ALERT SERVICE BULLETIN

205B-15-66
20 January 2016

MODEL AFFECTED: 205B

SUBJECT: Seat Belt Comfort Clips, Removal of.

Figure 1 – Seat Belt Comfort Clips

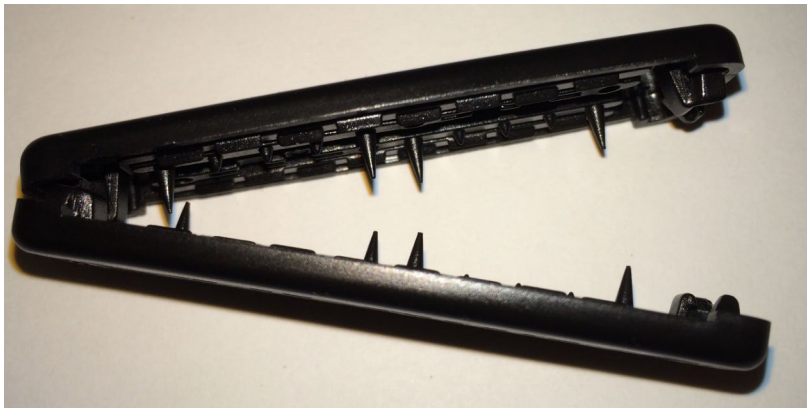
Bell Helicopter has become aware of an issue that affects the seat belt assemblies on Bell Helicopter models. This Service Directive requires the removal of all variants of comfort clips from all seat belt assemblies on the affected helicopters. Comfort clips D7LZ-6560286-A and D7LZ-6560286-B, which have been used on different seat belt assemblies, have been superseded to the 504636-401. We have identified concerns with the use of the comfort clips relevant to the designed safety features of the seat belt assemblies. We have since stopped delivering the comfort clips with our current production helicopter seat belt assemblies, and have made the parts no longer procurable from Bell Helicopter. Although this helicopter model was not affected by original design at the time of certification and delivery of the helicopter, we are making this bulletin applicable as the subject parts may have been installed post delivery to end owners/operators. Applicability of this bulletin to any spare part shall be determined prior to its installation on an affected helicopter.

1. Prepare the helicopter for maintenance.
2. Verify if seat belt comfort clips are installed on any of the crew or passenger shoulder harness seat belts (Figure 1). If installed, remove and discard.
